# HISTORIC AND DESIGN REVIEW COMMISSION

**HDRC CASE NO:** 2020-252  
**ADDRESS:** 328 E JOSEPHINE  
**LEGAL DESCRIPTION:** NCB 975 (BOEHLER'S SUBD), BLOCK 18 LOT 15  
**ZONING:** C-3, RIO-2  
**CITY COUNCIL DIST.:** 1  
**APPLICANT:** Kristen Weber/Don B. McDonald, Architect  
**OWNER:** RIO PERLA PROPERTIES LP  
**TYPE OF WORK:** Amendments to a previously approved design, new construction, site work  
**APPLICATION RECEIVED:** June 12, 2020  
**60-DAY REVIEW:** Not applicable due to City Council Emergency Orders  
**CASE MANAGER:** Edward Hall  
**REQUEST:**

The applicant is requesting a Certificate of Appropriateness for approval to amend a previously approved design. Within this request, the applicant has proposed the following:

# Boehler's Bar BBQ Pits, Roof & Stacks Addition

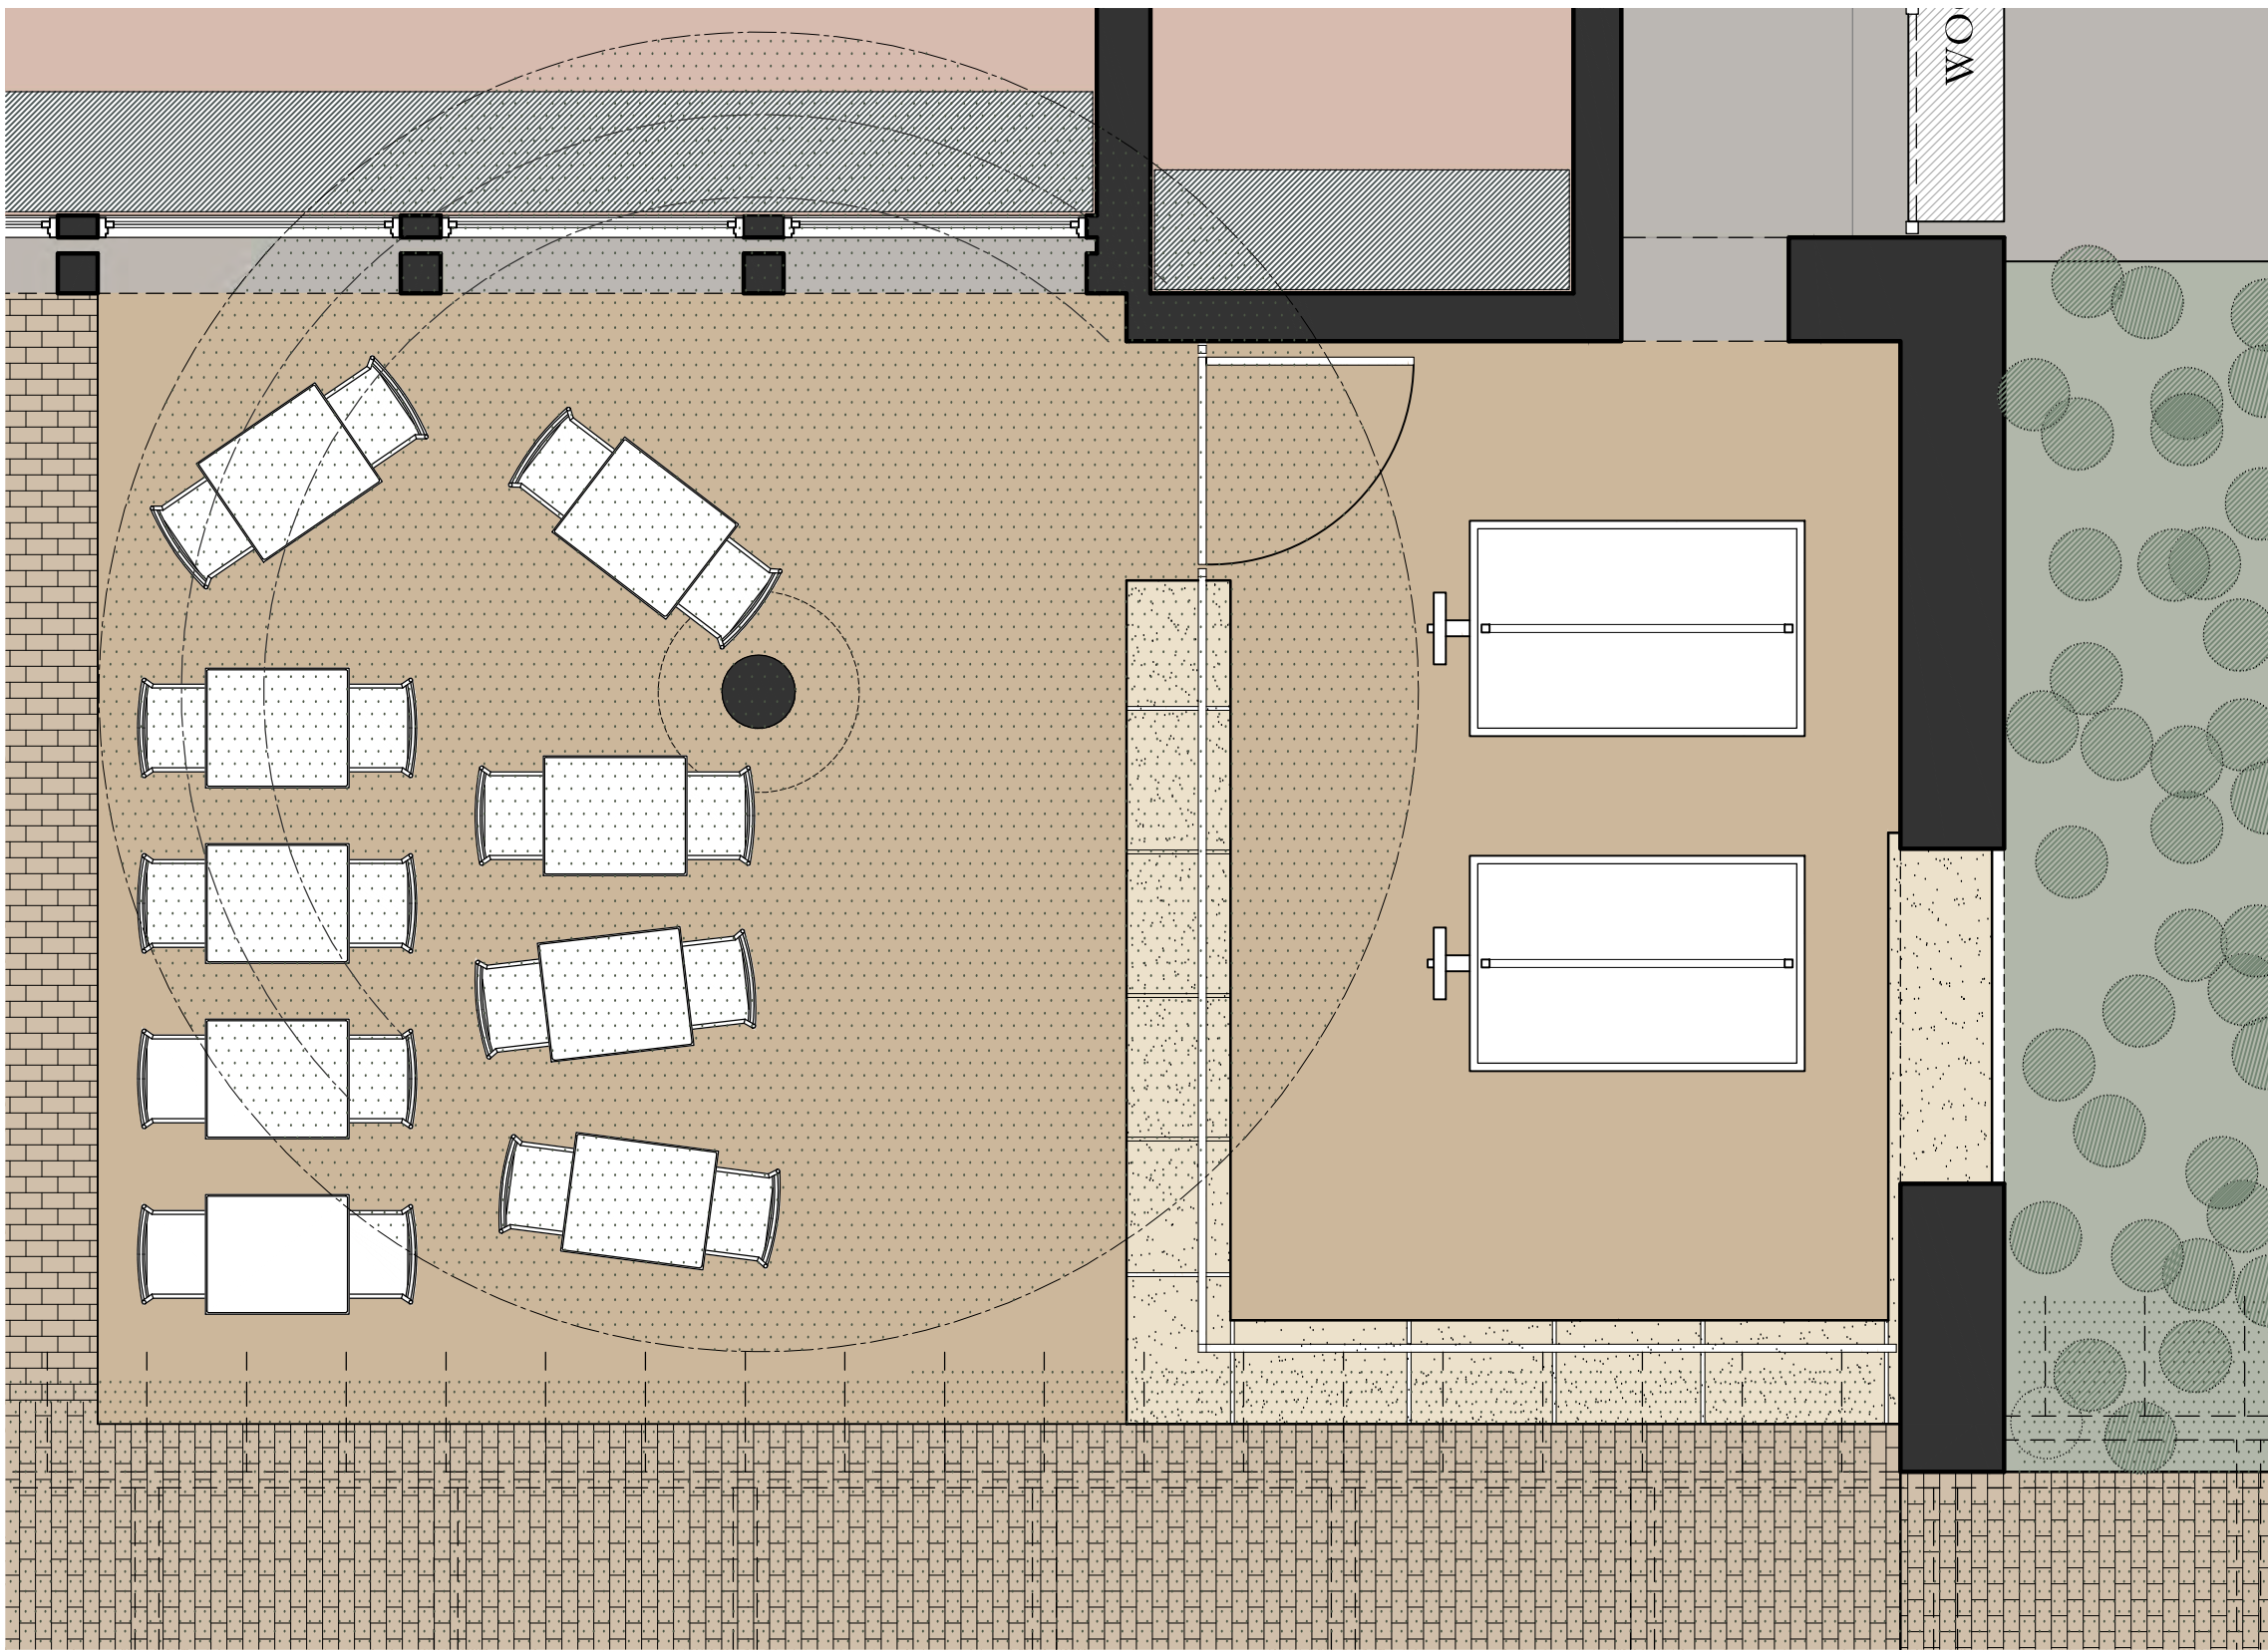
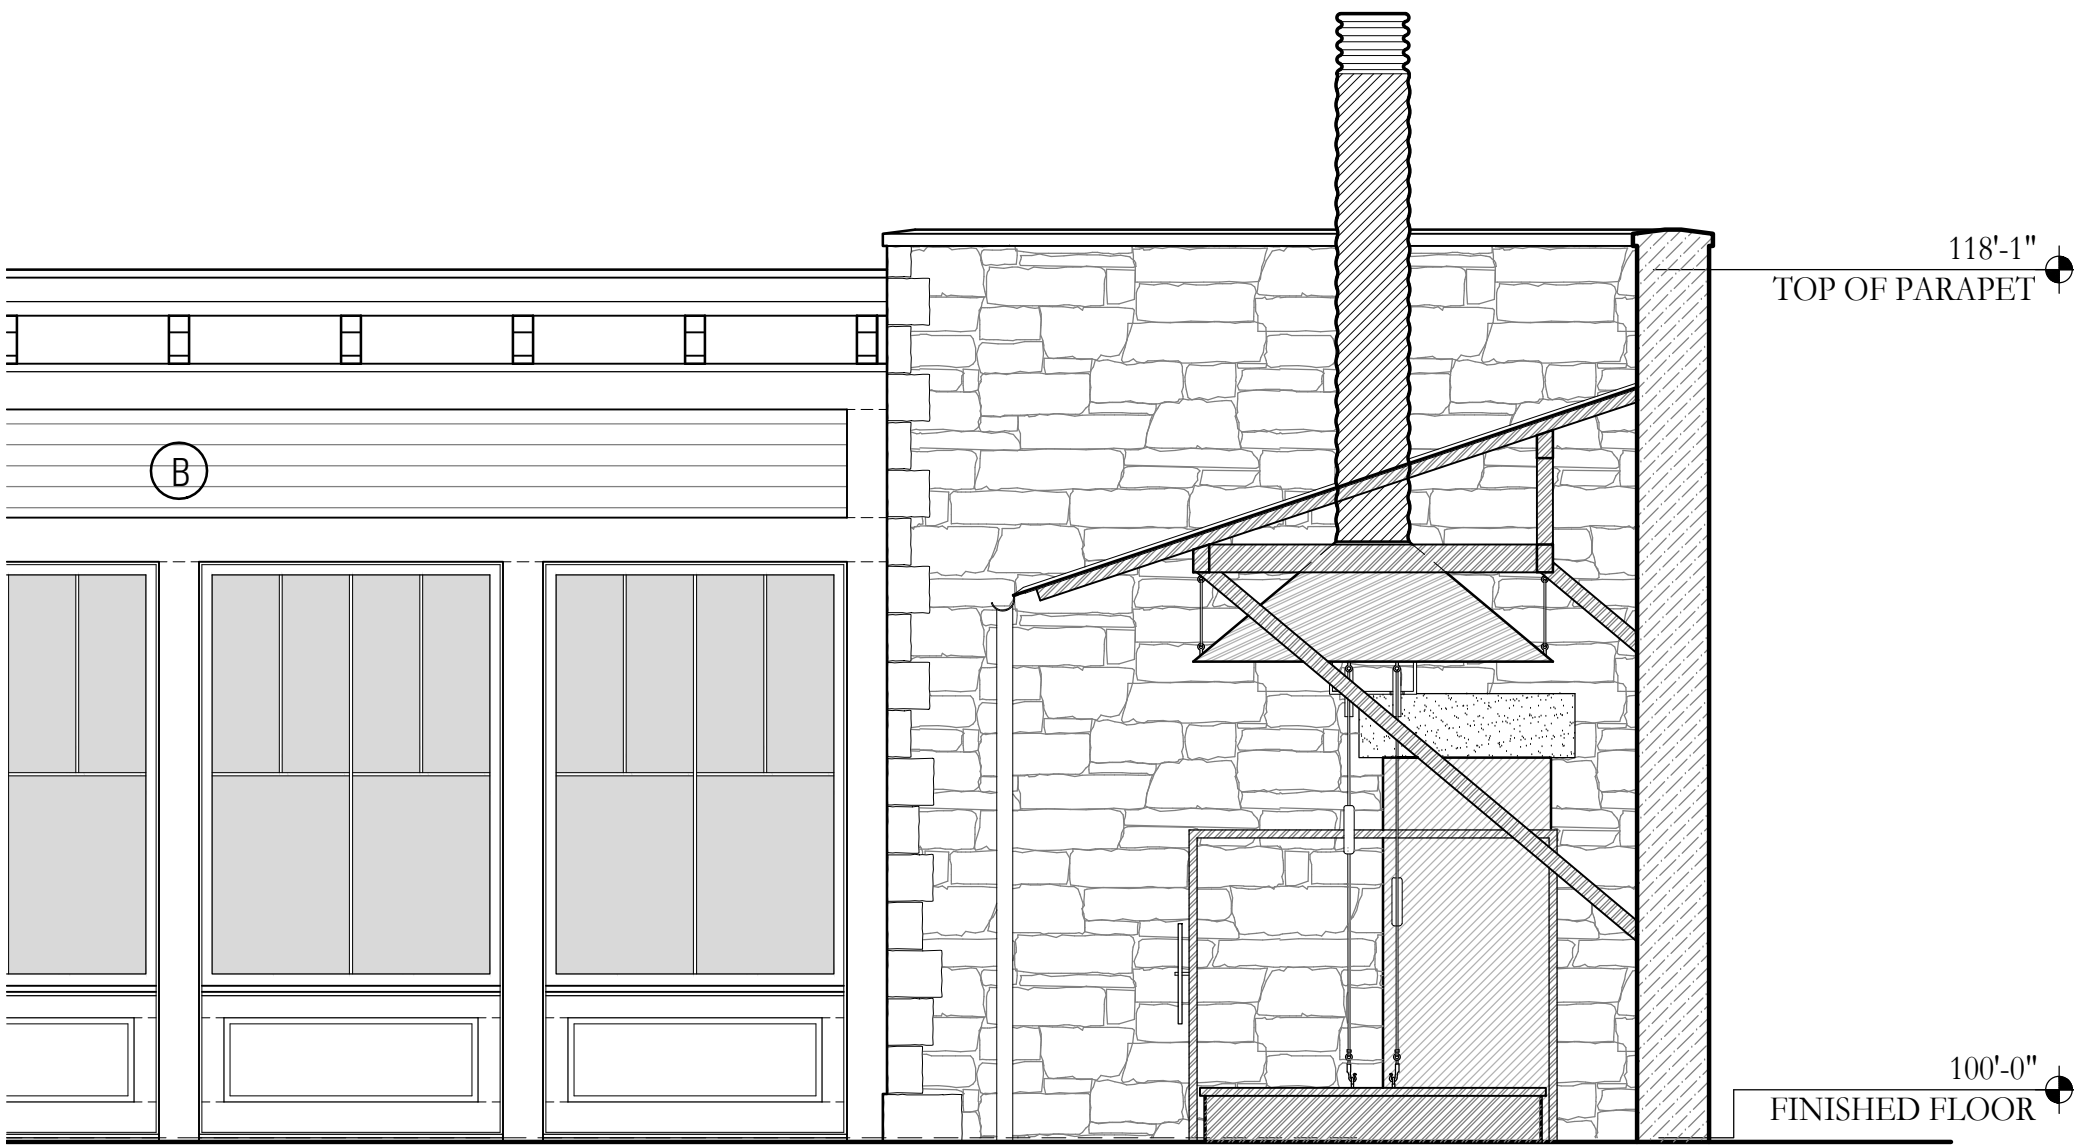
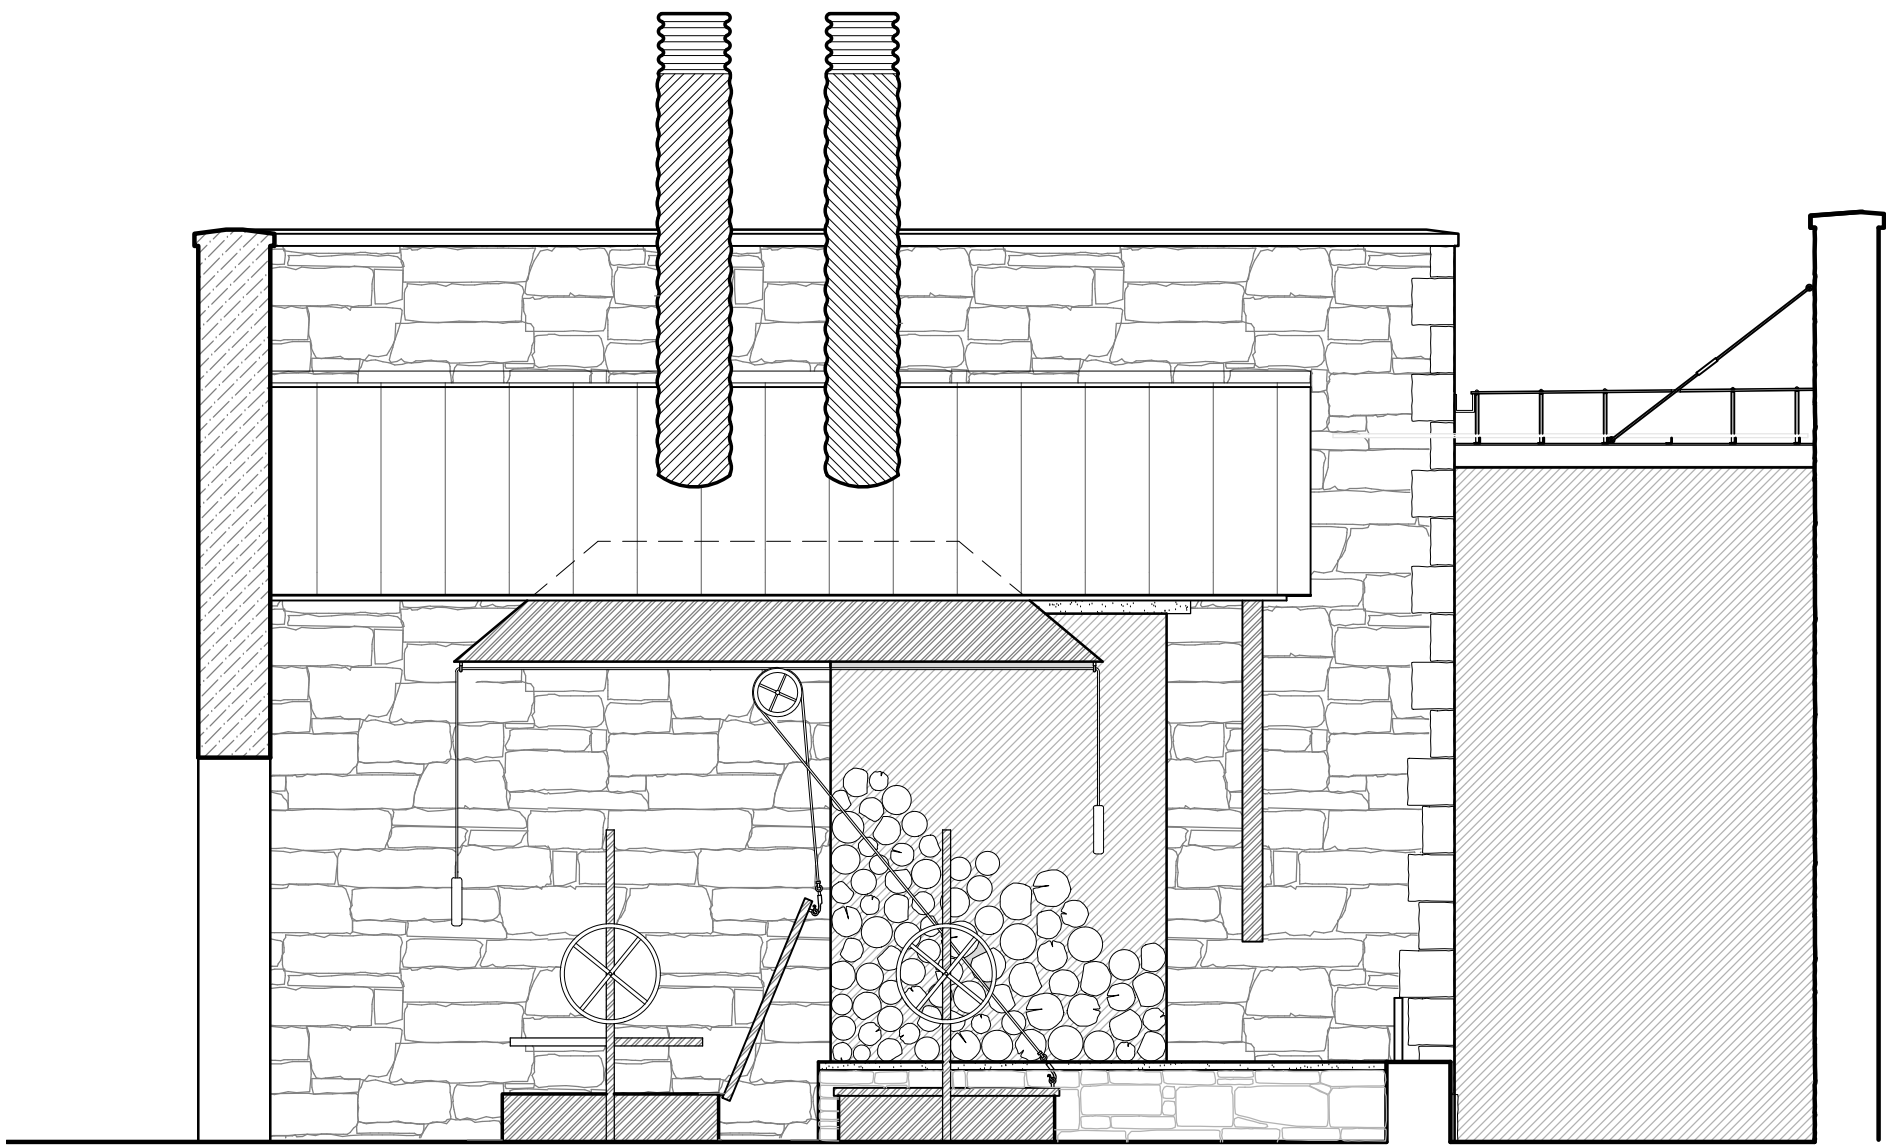
4. Shift the previously proposed north stone wall to the south to act as a parapet wall to the Boehler's Bar kitchen addition.
5. Create two barbeque pits and roofs with exhaust vents in the Boehler's Bar kitchen courtyard.

Parking Area Walls at  
Josephine & Ave. A

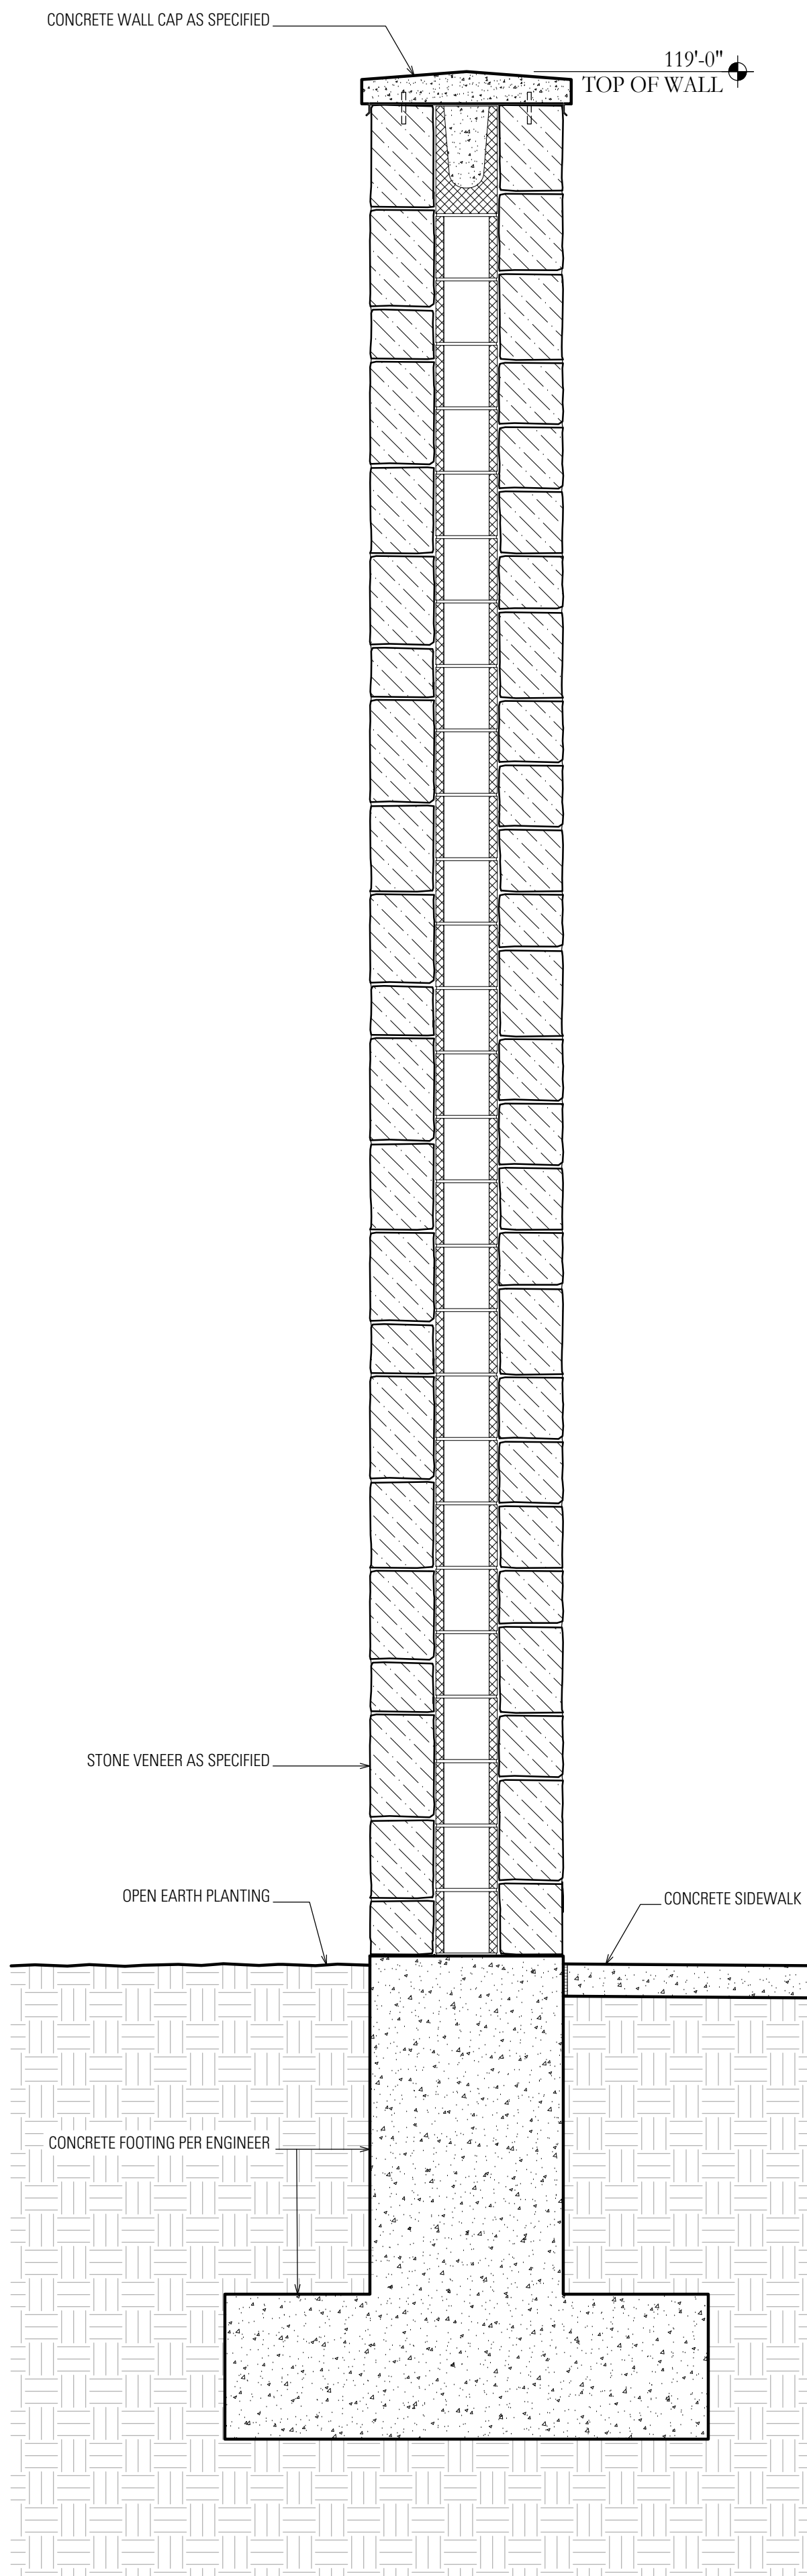
8. Construct a site wall to be located at the corner of Josephine and Avenue A to span the length of the original location of Boehler's and at the corner of the property along Josephine. Two additional low walls are proposed at the Josephine Street parking approach and the Avenue A pedestrian circulation.

A stone wall at the corner of Josephine Street & Avenue A is proposed to mediate the scale of the highway & exit ramp with the granular conditions of the neighborhood. The wall runs the length and width of the original Boehler's Bar and speaks to that historic context. Vines planted inside will cascade over the wall to reinforce the contained courtyard and offer a prelude to the exotic planting beyond. A second wall is proposed further west on Josephine to terminate the parking lot arbor.

Two low walls are planned at the Josephine Street Parking approach and Avenue A Cottage pedestrian passage. These walls mediate the relationship between the Portals and dense foliage.
